CONSTRUCTION OF LA CASA

Solicitation No. DCAM-12-CS-0159

Addendum No. 2
Issued: May 23, 2012

RFI RESPONSES TO OFFEROR QUESTIONS FOR THE
NEW CONSTRUCTION OF LA CASA SUPPORTIVE HOUSING FACILITY

DRAWING NUMBER: DU.01

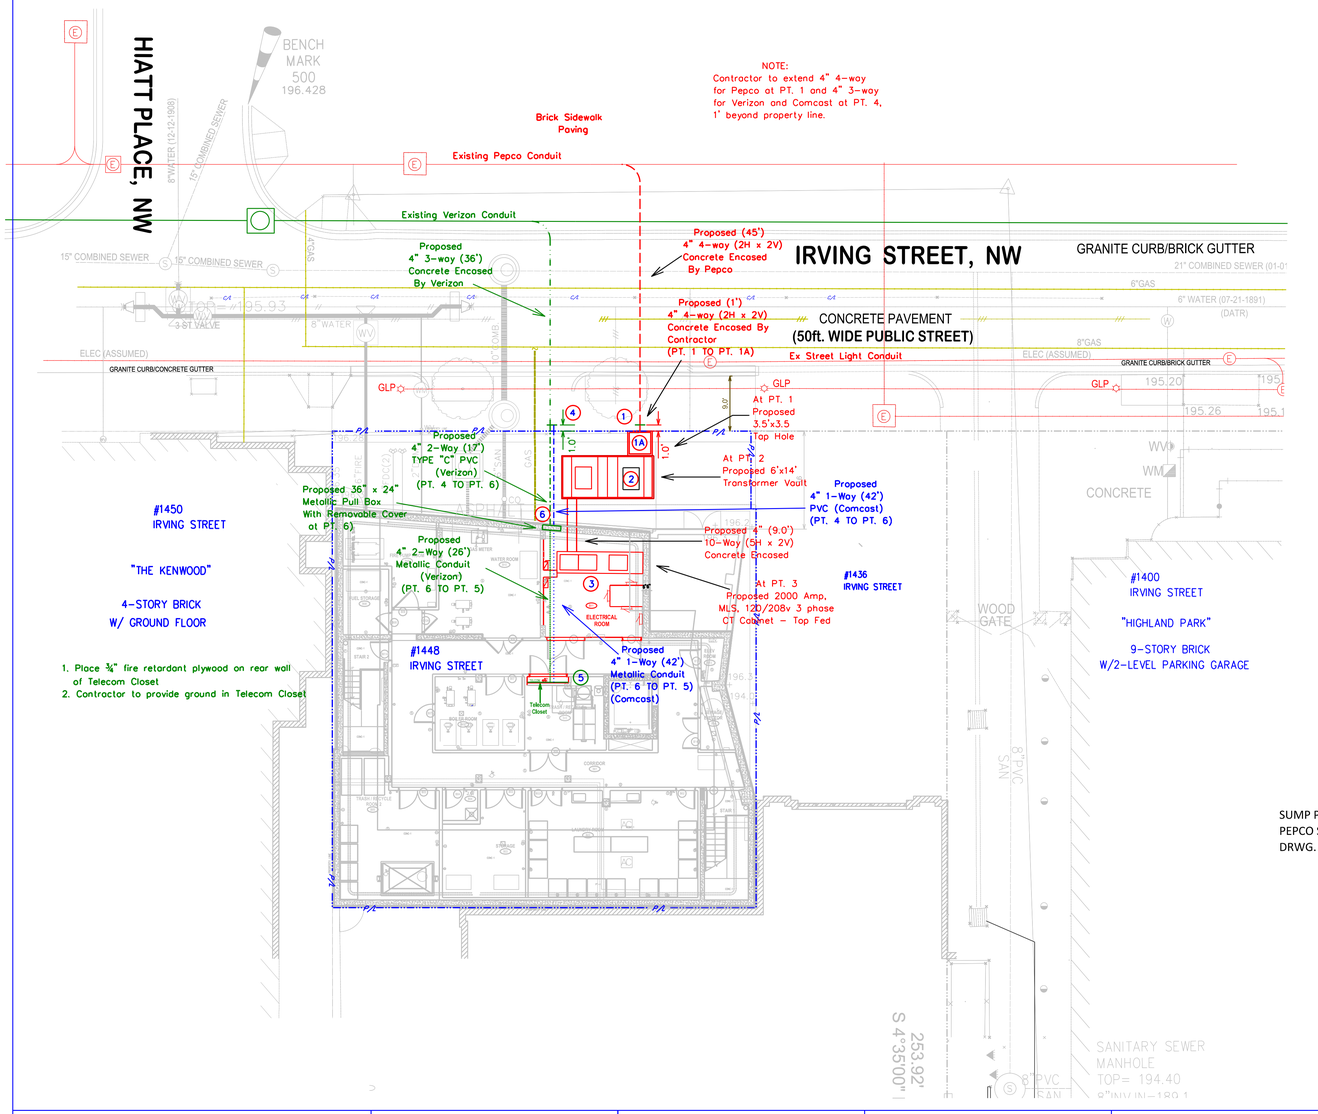
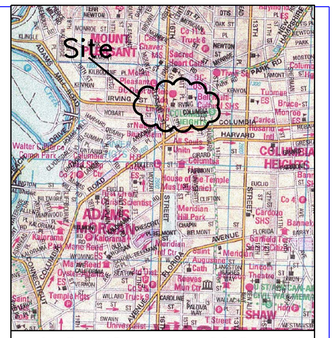
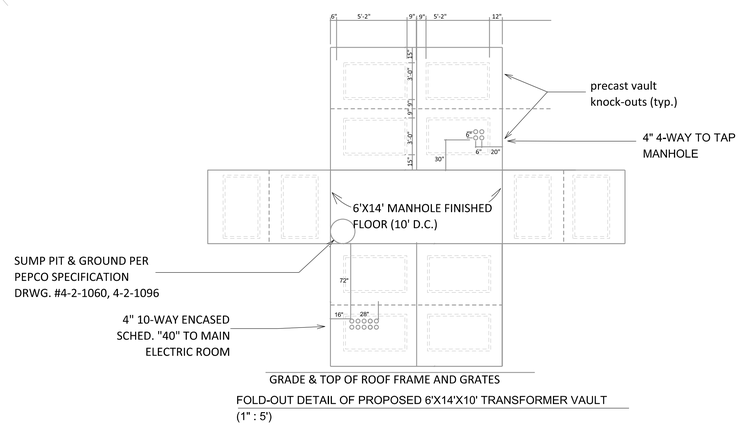
Z. Add new sheet "DU.01" to the bid documents. See attached sheet.
